## Memorandum to the City of Markham Committee of Adjustment March 14, 2025

File:	A/006/25
Address:	365 Hood Road, Markham
Agent:	API Development Consultants Inc. (Natalia Garavito)
Hearing Date:	Wednesday, March 19, 2025

The Applicant is requesting relief from the following requirements of the "Employment – Business Park (EMP-BP)" zone under By-law 2024-19, as amended, as it relates to a proposed 15-storey hotel. The variances requested are to permit:

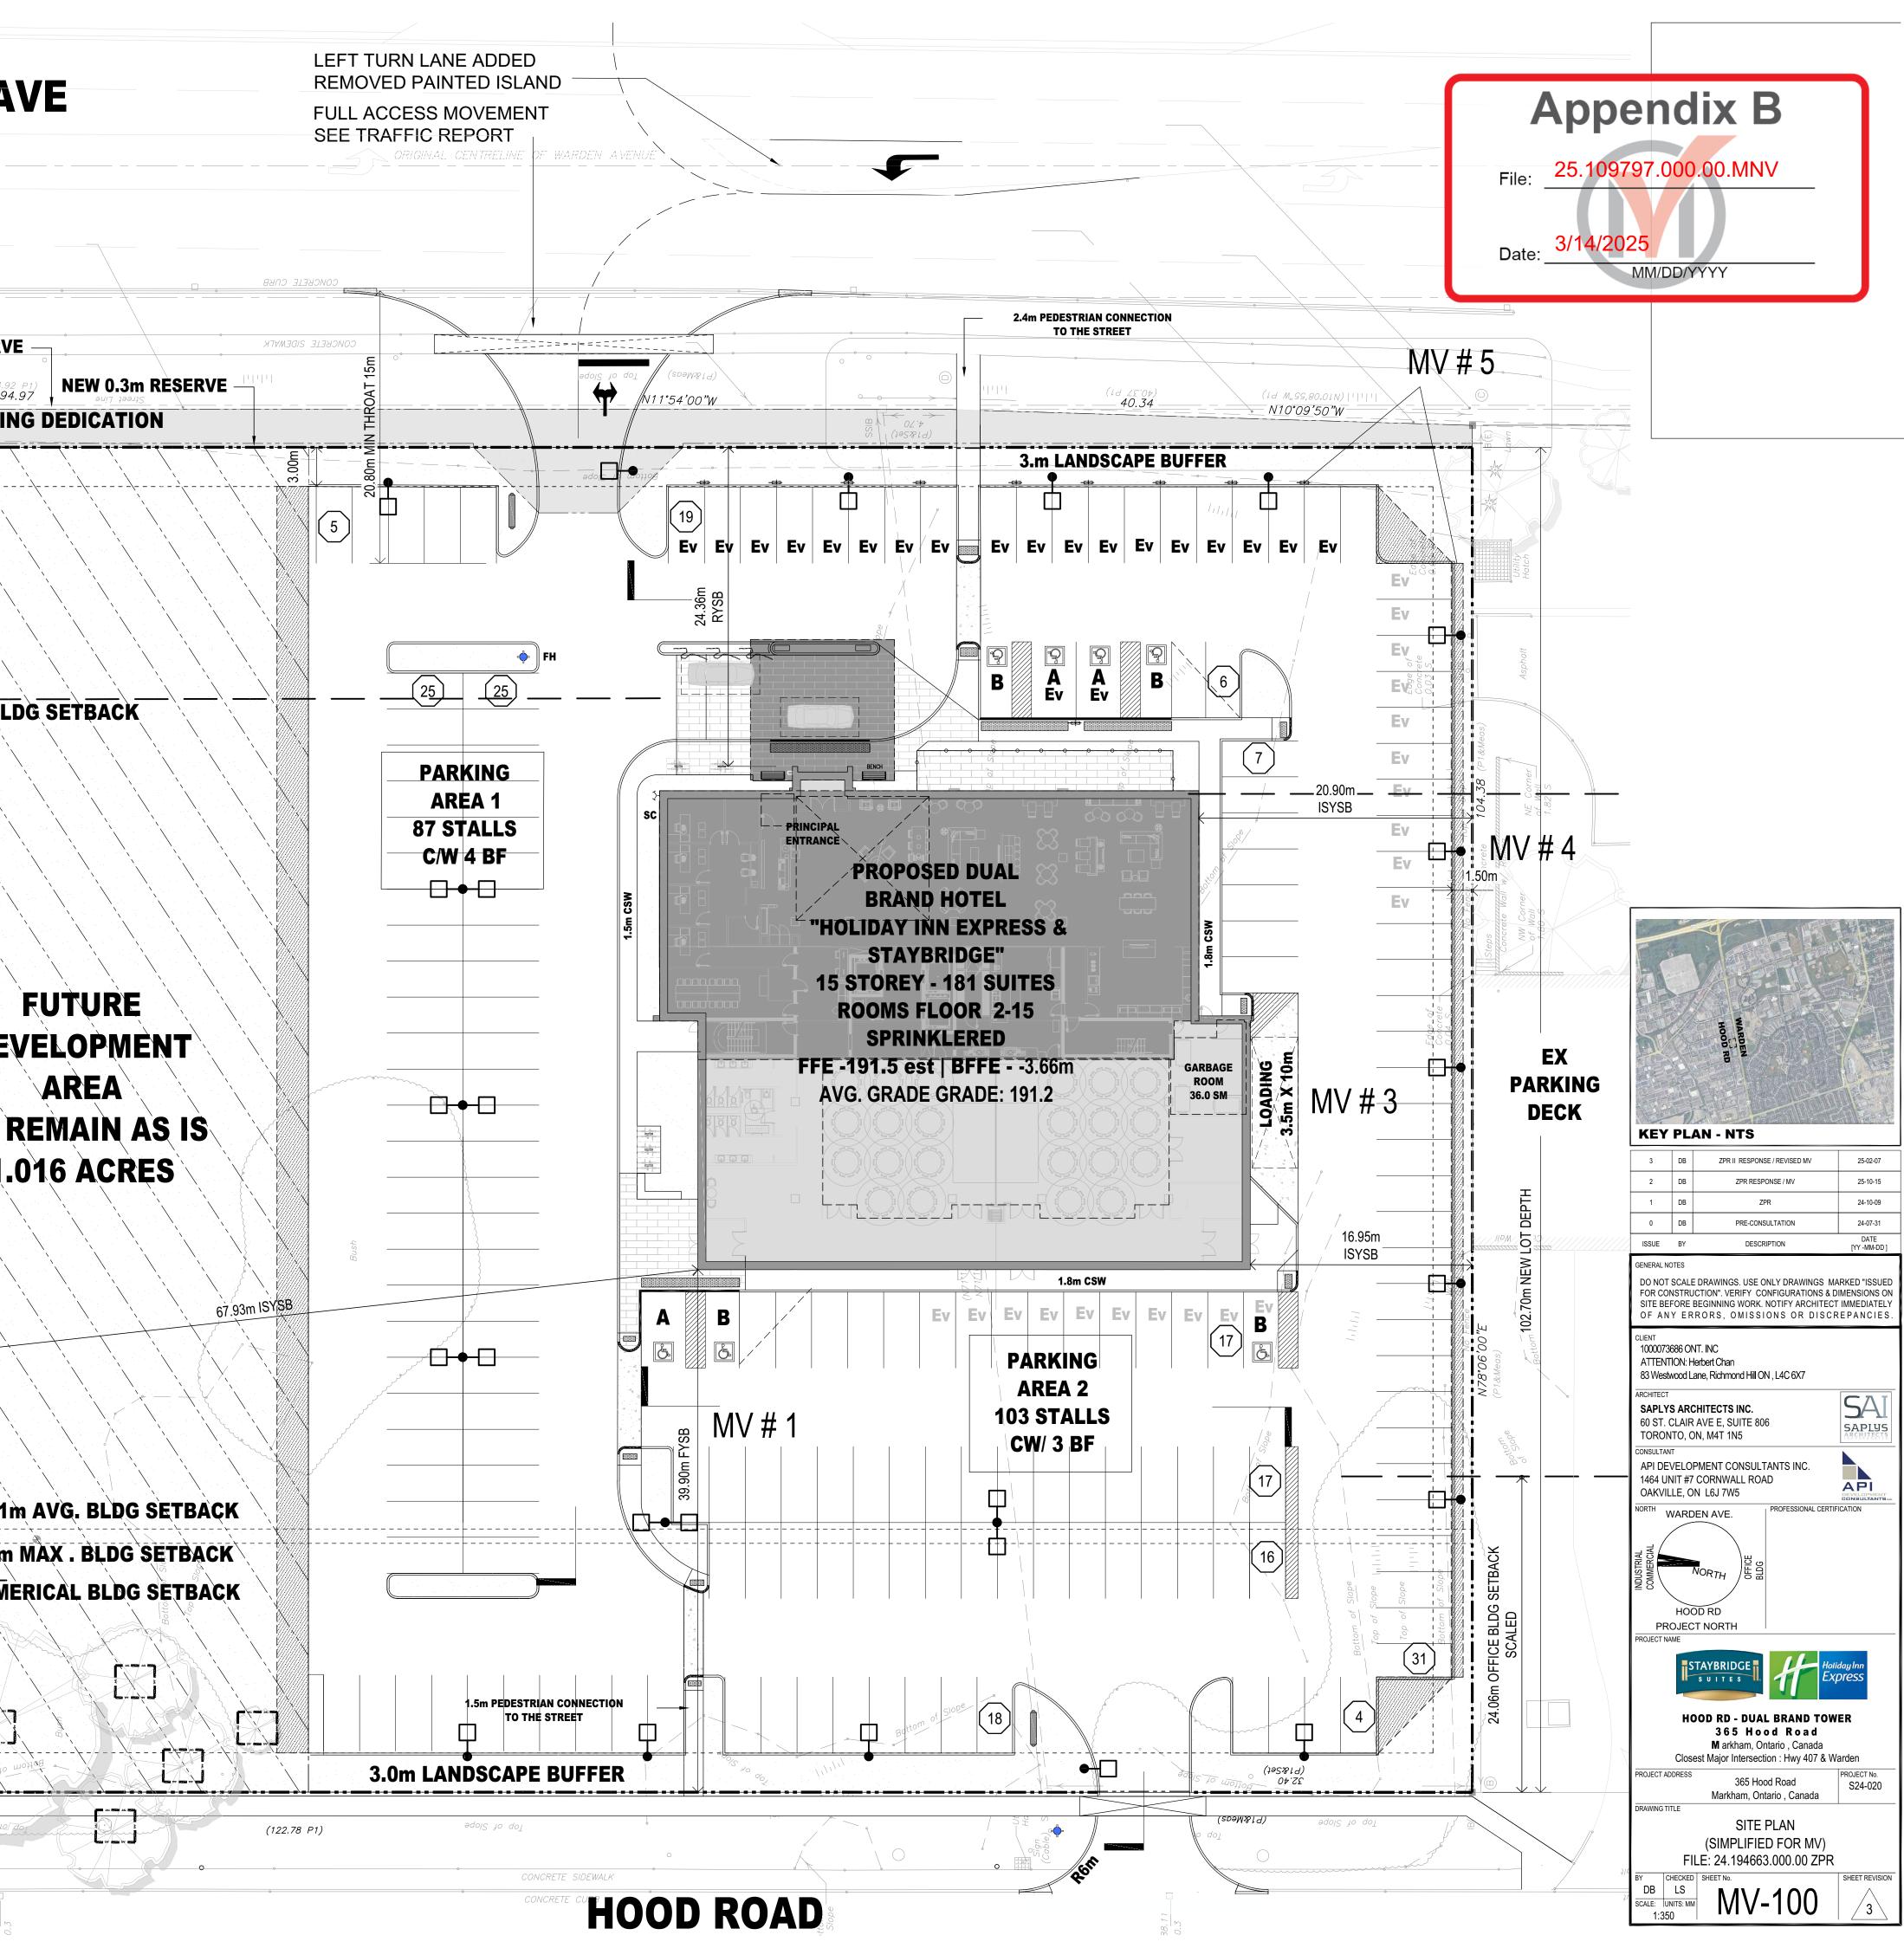
The Applicant is requesting relief to permit a maximum front yard setback of 39.9 m (130.9 ft) from Hood Road, whereas the By-law permits a maximum front yard setback of 20.1 m (65.9 ft). The general intent of the front yard setback requirement is to maintain a consistent setback and streetwall along Hood Road.

The Subject Lands is a through-lot with frontage on both Hood Road and Warden Avenue. However, through the review of the ZPR, it has been confirmed that Hood Road is deemed to be the front lot line. It should be noted that the By-law defines the front lot line for a through-lot to be the longest of the lot lines which divides a lot from the street.

Based on preliminary discussions with Urban Design (UD) Staff to improve the design of the proposed development and to enhance the presence of the proposed hotel along Warden Avenue (a major arterial road), the Applicant agreed to situate the proposed development closer to Warden Avenue. The proposed variance request for relief from the maximum front yard setback is entirely attributed to addressing UD's comments in providing an improved development with a prominent presence along a major arterial road and which would enhance the public realm along Warden Avenue.

Furthermore, Staff note that the main entrance of the proposed hotel will face the rear lot line (Warden Avenue) and is setback 24.36 m (79.9 ft) from the rear lot line. Given that the proposed orientation of the building, in which the main front entrance and primary vehicular access is from Warden Avenue, Planning Staff are of the opinion that the rear lot line of Warden Avenue can be interpreted as the front lot line which generally complies with the By-law requirement. As such, Staff opine that the variance request meets the intent of the By-law.

The Applicant is requesting relief to permit electric vehicle stations within a landscaping strip, whereas the By-law does not permit it.

The Applicant provided justification that lighting standards are already permitted in landscaping strips and serves as a logical location for electric vehicle charging infrastructure as they can be integrated without consuming valuable parking spaces or obstructing pedestrian pathways. For the purposes of snow removal, providing the electric vehicle stations within landscaping strips also allow for the parking lot to be cleared without potential damages to the stations. The Applicant also noted that the electric vehicle stations are compact, low-profile, and emit minimal heat, ensuring no adverse effects on surrounding vegetation.

The Applicant is committing to work with UD Staff through the SPC application process to ensure that the electric vehicle stations will be screened and will not be visible from the street. As such, Staff considers this variance to be minor in nature and have no objection.

The Applicant is requesting relief for a minimum of 1.5 m (4.9 ft) wide landscaping strip abutting the south interior side lot line, whereas the By-law requires a minimum landscaping strip of 3 m (9.8 ft).

The Applicant noted that this is a new standard under By-law 2024-19, whereas 1.5 m was previously the norm until the By-law was recently passed. The Applicant also noted

that the site to the south of the Subject Lands currently has a landscape strip that is wider than 3 m (9.8 ft), and if the site to the south is to be redeveloped, a collective landscaping strip of 4.5 m (14.7 ft) between the two sites can still be provided.

UD Staff have no strong views against the justification provided by the Applicant, and Staff consider the variance to be minor in nature and have no objection.
